31 July 2018

PDR 18545

**RE: Proposed dam for W & C Fabris and A & B Fabris at 1091 Wolfram Road Dimbulah – certification of design**

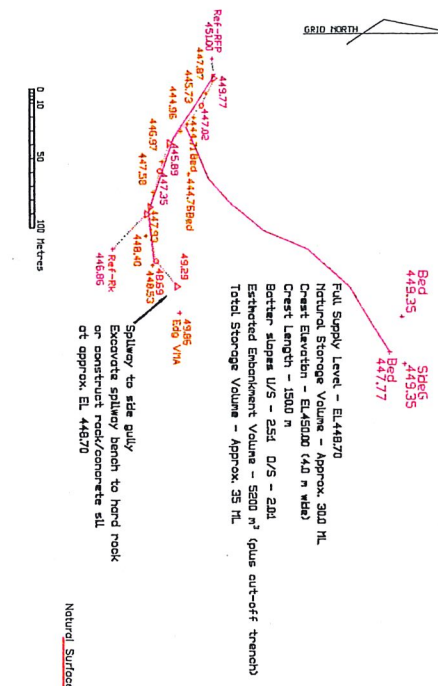
1. The clay cut-off trench is to be a minimum of 2.5 metres thick and a minimum of 1.5 metres deep and is to be extended into the underlying rock. If rock is encountered at less than 1.5 metres, then the bottom of the trench is to extend into the rock by 300mm.

2. Where stiff clay is encountered in the cut-off trench the cut-off wall must extend a minimum of 1 metre into the clay. This trench must be checked for soundness and integrity prior to the placement of the clay core (zone 1 material) in the trench.

3. When the area is stripped for the construction of the wall and cut-off trench any fissures found in the underlying rock shall be cleaned out and sealed with compacted clay.

4. The zone 4 material used to provide protection to the upstream and downstream face of the dam is preferred to be medium quarry rock with a minimum thickness of 300mm.

5. The rock lined spillway channel is to be provided with a 1 metre deep, 450mm thick toe at the upstream and downstream end of the spillway. The spillway channel is to be 40 metres wide, 1.3 metres deep and return to the gully. At construction time the bed of the overflow

channel needs to be inspected for resistance to erosion and, if the inspection reveals that protection is required, then it shall be lined with rock with a minimum dimension of 300mm.
